NEW
RIVER

Burgess Hill

Design & Access Addendum

Proposed Section 73 Amendments

Proposed Ground Floor Plan - Level 01

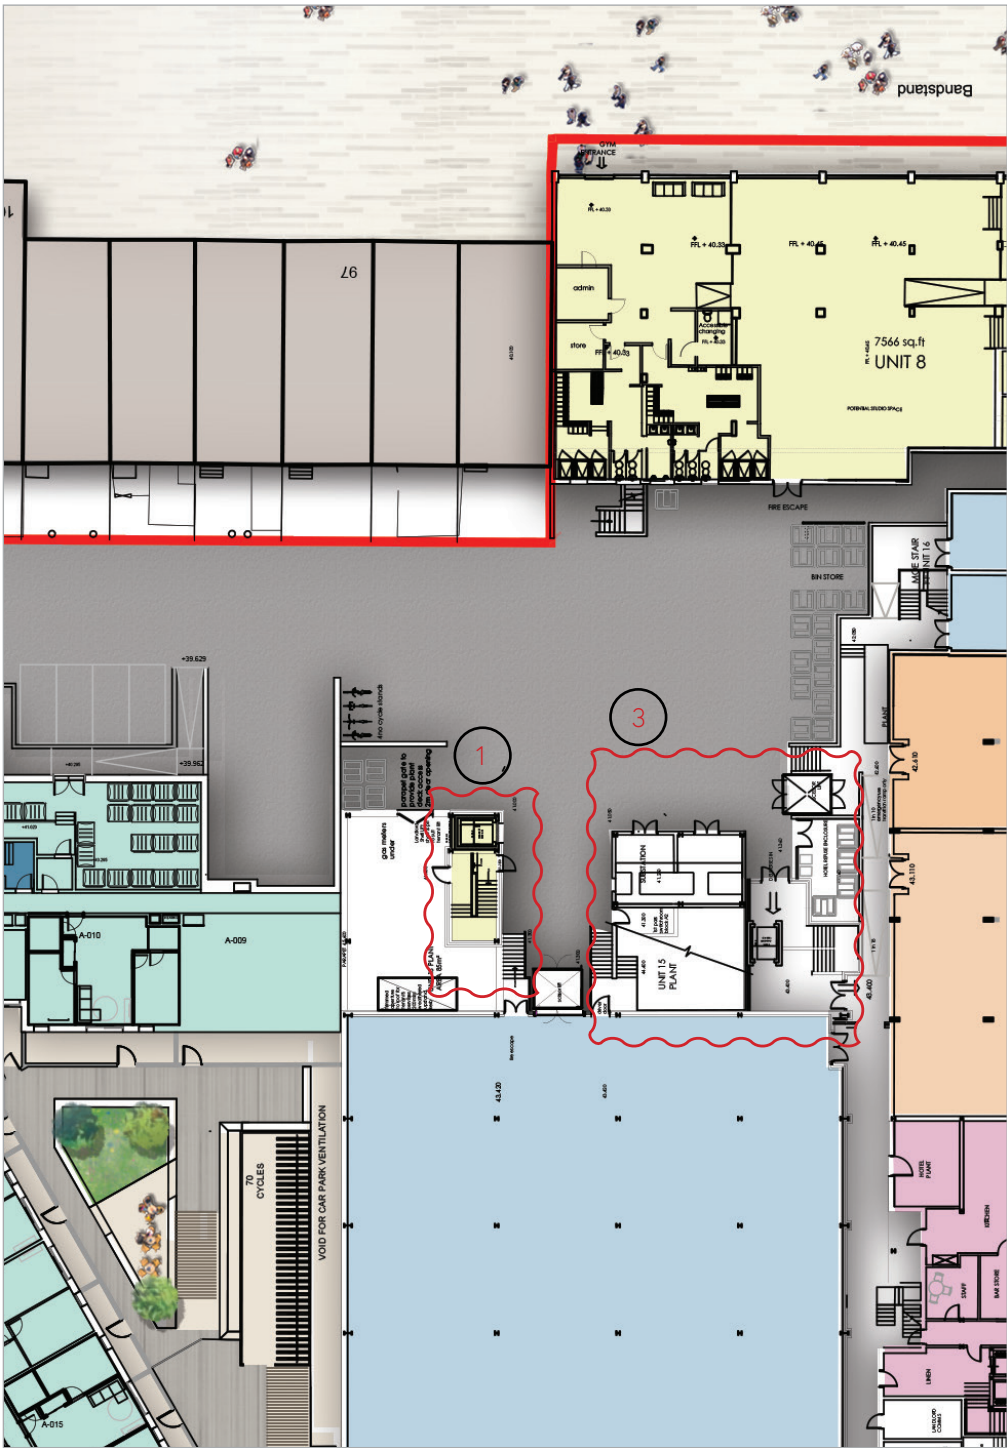
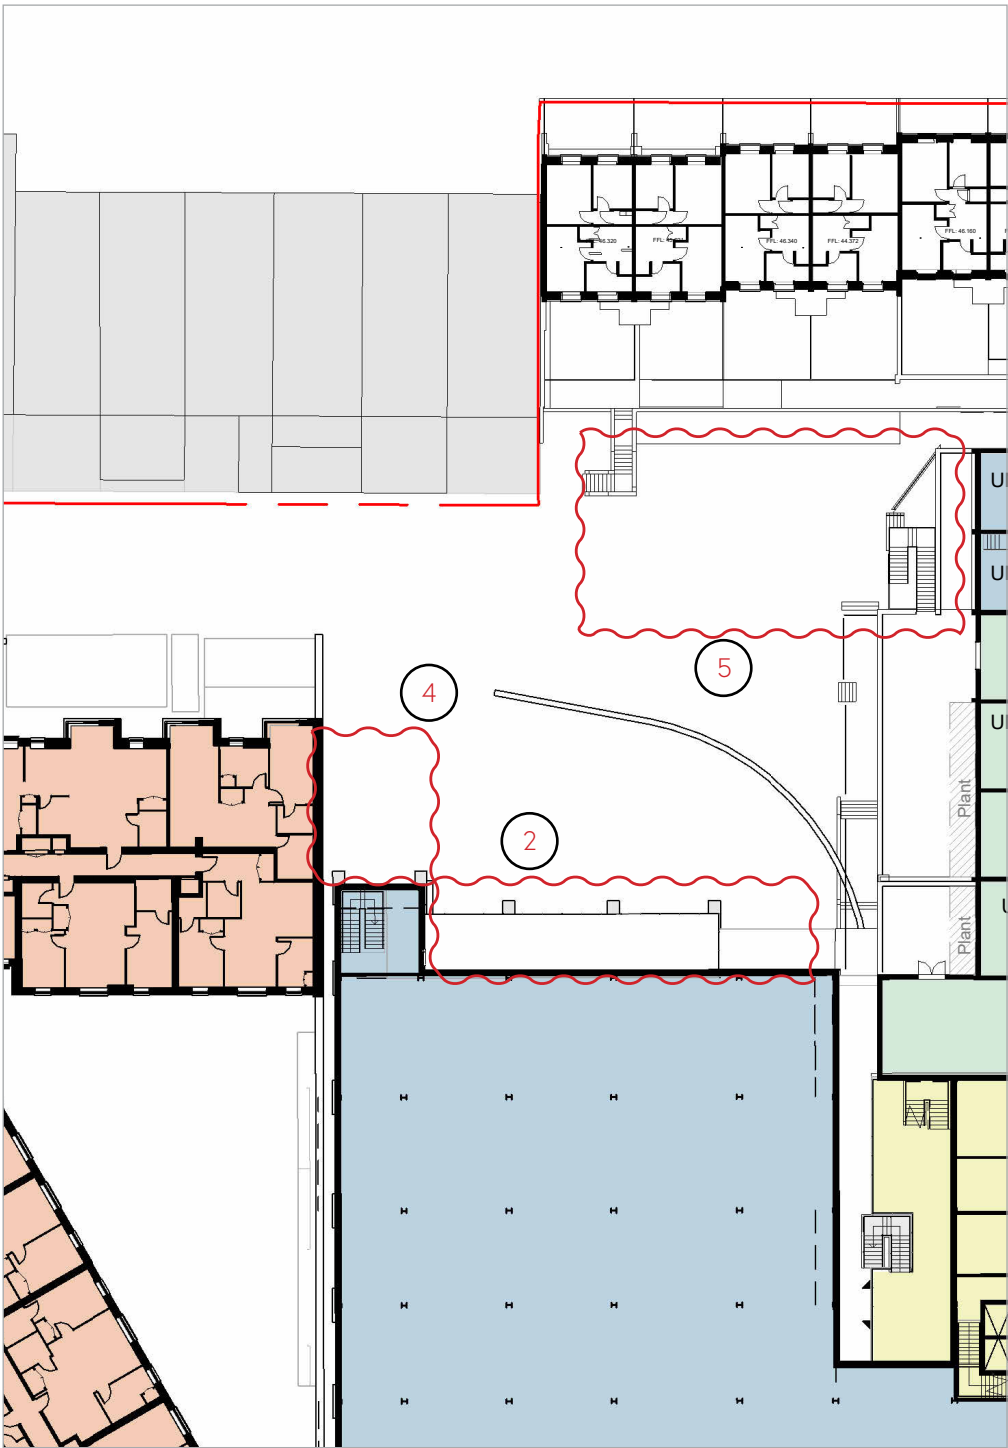
- 1. Omission of basement level access simplifies the external ground levels required and in turn the serviceability of the service yard.
- 2. Ground level in the service yard adjusted to facilitate the loading bay sitting level with both Aldi and Travelodge ground floor levels.
- 3. Stairwell and lift connecting the service yard and rear access to the Hotel are omitted as level access is now provided for all deliveries.
- 4. Sub-Station relocated to the boundary with the Residential Block (A1). Following engagement and calculations a double sub has been confirmed.
- 5. Following the re-design of the service yard, tracking of vehicular movements, revisions to the proposed buildings and changes to the external levels necessitates a re-design of the refuse storage in this area.

Proposed Ground Floor Plan - Level 01

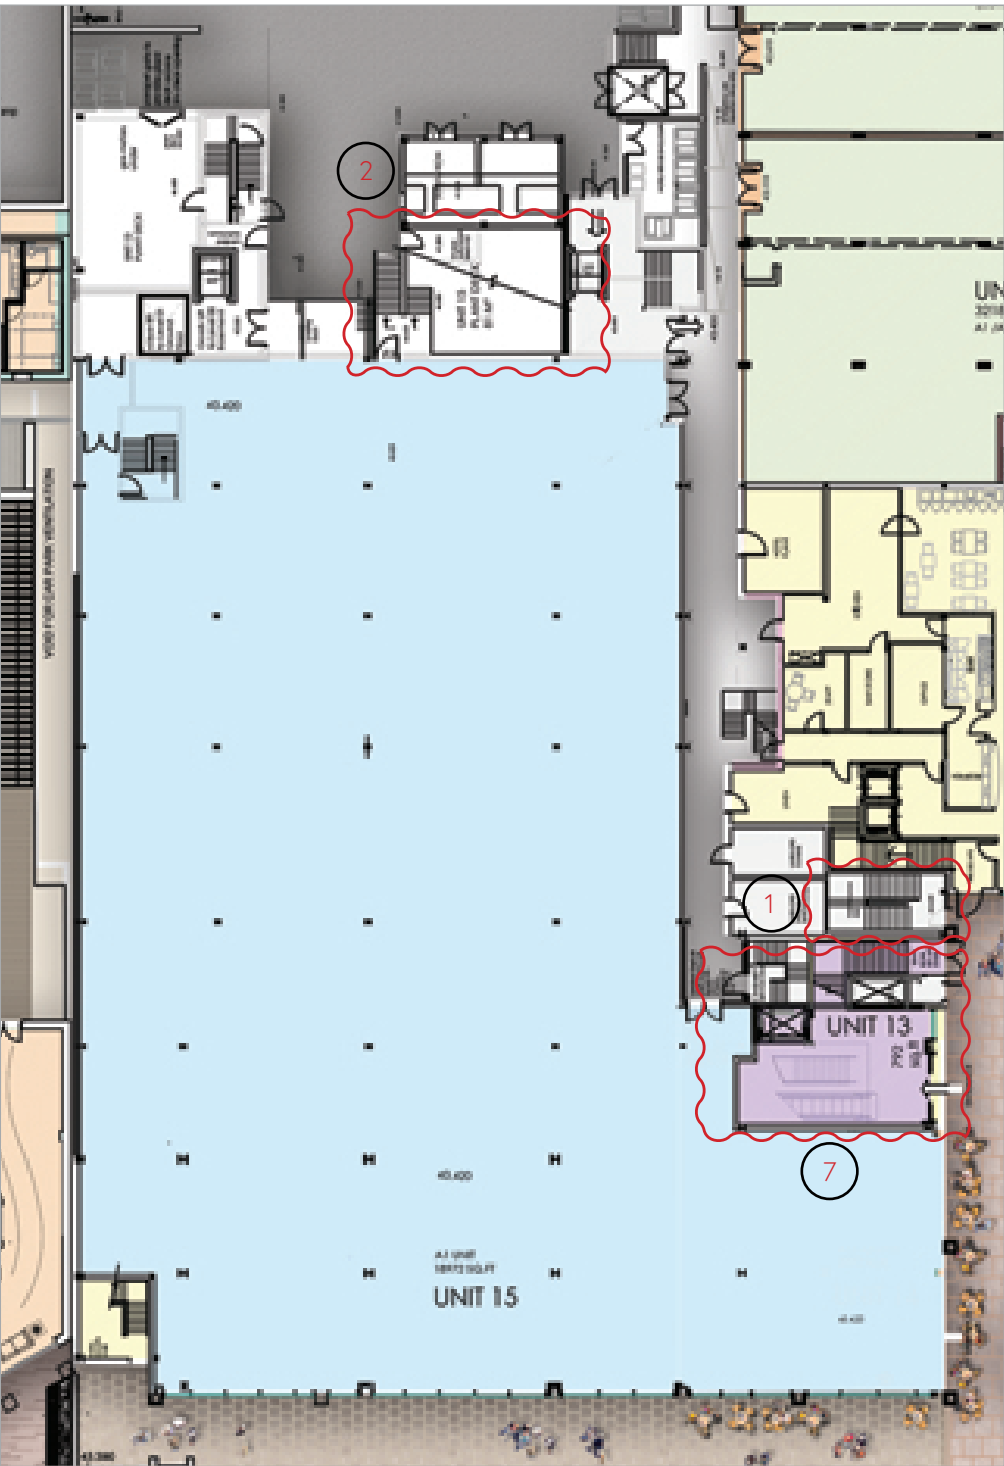
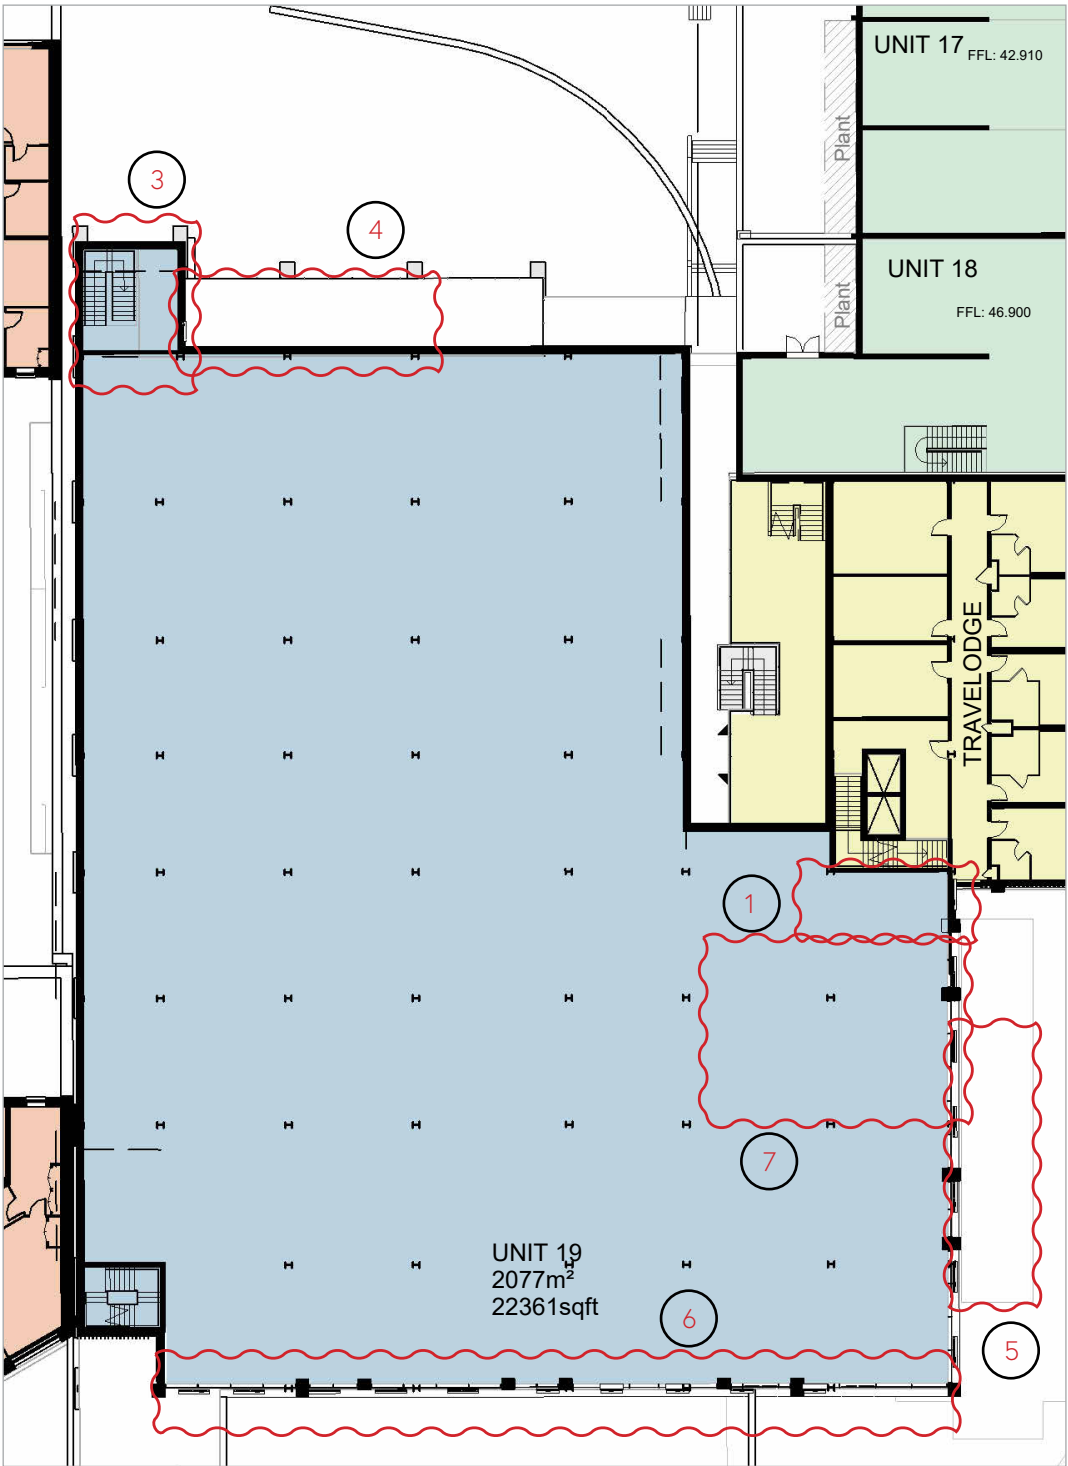
- 1. Isolated maintenance stair (and associated riser room) which provided separate access to the roof level of Block A2 for maintenance of the Telecom Mast has been omitted, footprint of the stairwell at Ground Floor Level is absorbed within the Food store increasing the overall store size.

- 2. Plant Space for the Food Store relocated from the service yard to the plant deck at Level 02.
- 3. Access to the Plant deck will now be provided via a dedicated stair core which is located where the Bowling Alley Plant area is no longer required.

- 4. Loading Bay re-designed to tenant requirements which includes a security curtain and a single pair of double doors for fire escape from the retail space.

- 5. External trolley park with canopy structure proposed adjacent to the food store entrance in line with Tenant requirements.
- 6. Elevational adjustments to align columns at ground floor with the bays of the hotel above.

- 7. Omission of the entrance lobby and stair for Unit 13/Bowling Alley. Footprint at Ground Floor Level is absorbed in the food store footprint.

Proposed First Floor Plan - Level 02

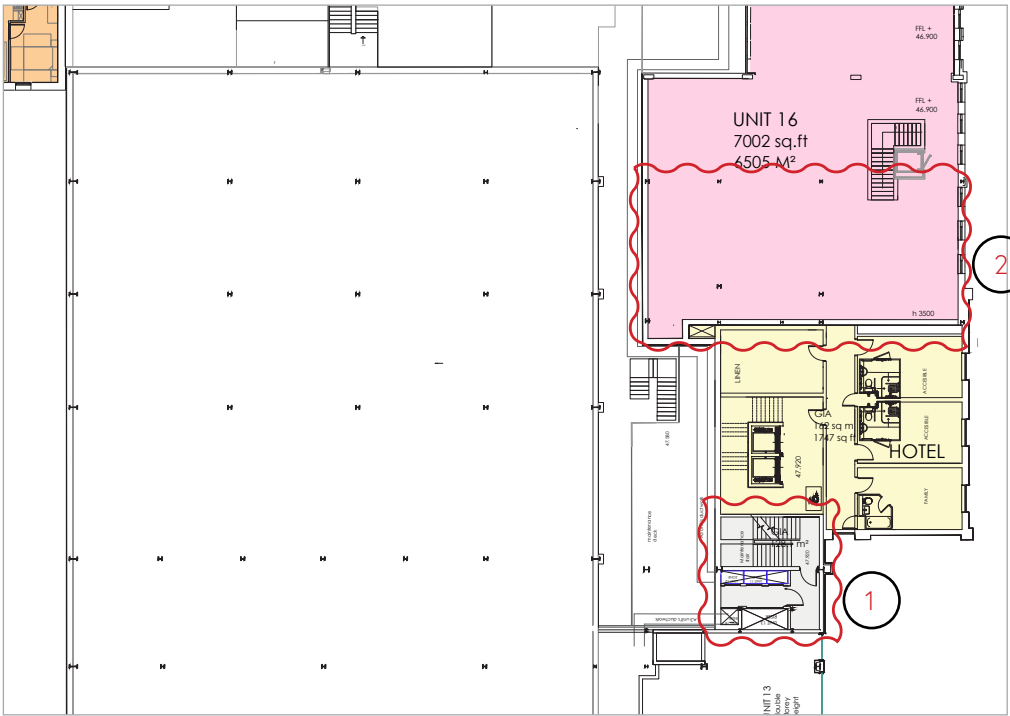
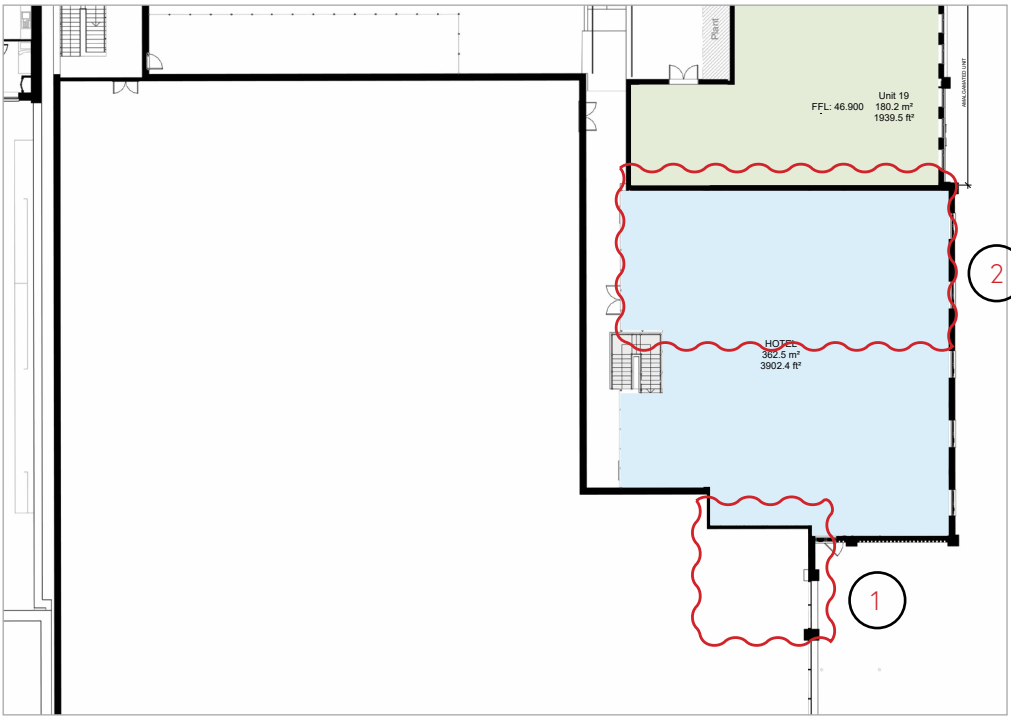
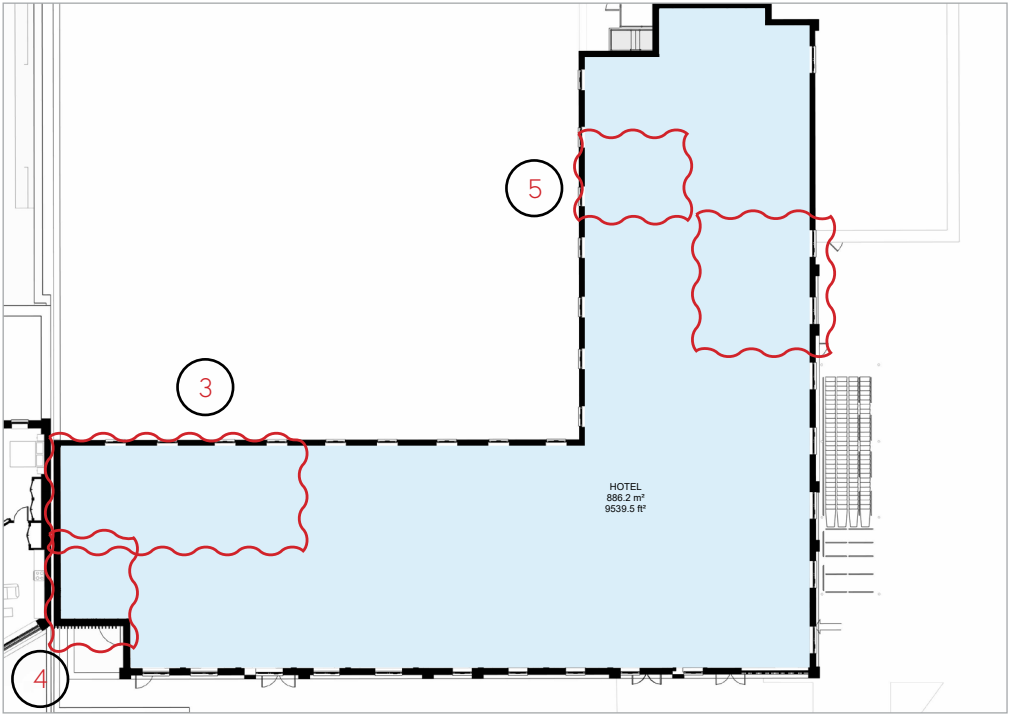
- 1. Isolated maintenance stair (and associated riser room) which provided separate access to the roof level of Block A2 for maintenance of the Telecom Mast has been omitted. At Levels 03/04/05 this space is attributed to the hotel enabling two additional rooms (1 Family & 1 Double) on each floor. Total plus 6 additional rooms.

- 2. At Level 02 the hotel demise has been extended into the retail space (previously Unit 12). This enables the hotel demise to stack with the ground floor footprint rather than overlapping tenants. The additional footprint at Level 02 has been allocated as 2 additional Family rooms and Plant/Staff rooms as per the tenants Back of House requirements. Total plus 2 additional rooms.

- 3. Plant deck on the north facing rear elevation at Level 05 has been relocated to the flat roof of Level 02 with direct access via the plant deck from the service yard. The area of the building is infilled to stack with Level 04 which provides 4 additional double rooms. Total plus 4 additional rooms.

- 4. Secondary escape from the roof level is provided via an access hatch into the stair core on the boundary with Block A1.
- 5. Following design development of the M&E strategy the Internal Plant Room on the west facing rear elevation of Level 05 has been confirmed as not required. The revised scheme reassigns this area as an additional double room. Total plus 1 additional room.

- 6. Total Number of Hotel rooms has increased from 89 rooms to 102 rooms.

Proposed North West Elevation

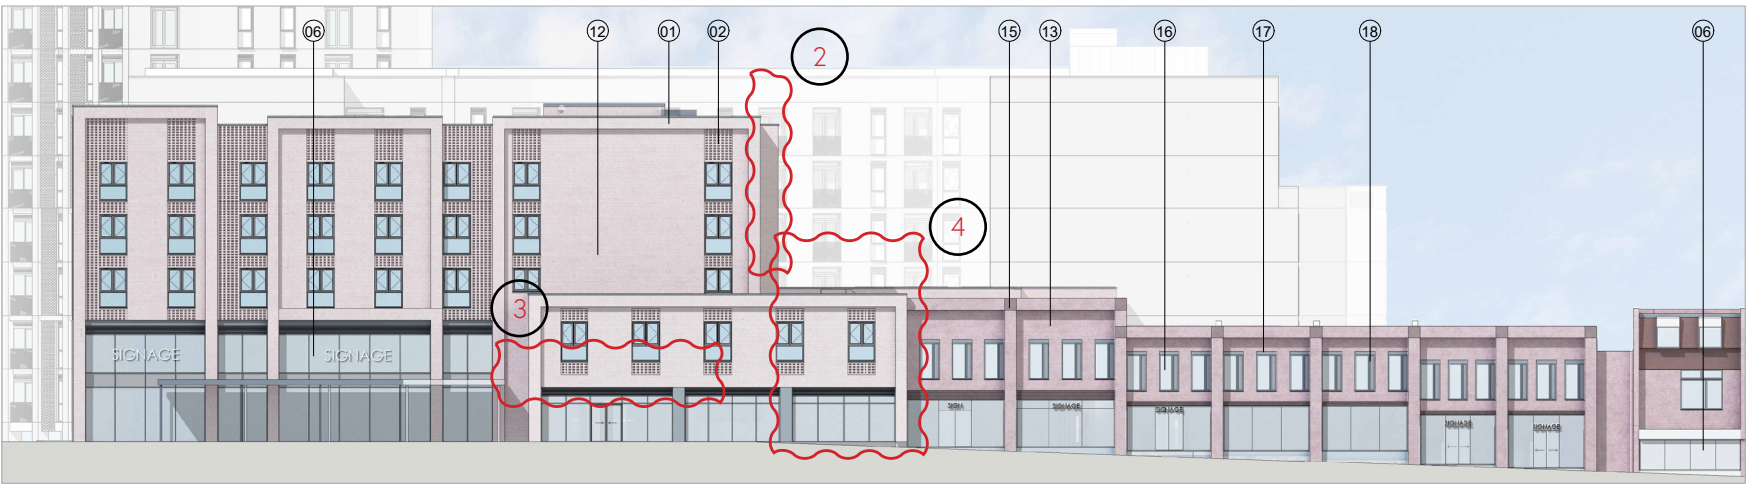
1. Façade bays adjusted to suit internal room widths in accordance with tenants standard room sizes.
2. Risers for Telecoms Mast relocated to the North facing elevation following the omission of the separate maintenance stair. Hotel tenant has confirmed roof access via the hotel stair is permitted.
3. Hotel Entrance Canopy omitted. Following user input, the hotel operator requested the omission of the canopy over the hotel entrance as it promotes unwanted congregation and smoking at the entrance of the hotel.
4. Extension of the first floor demise facing the existing Library to stack with the ground floor footprint.
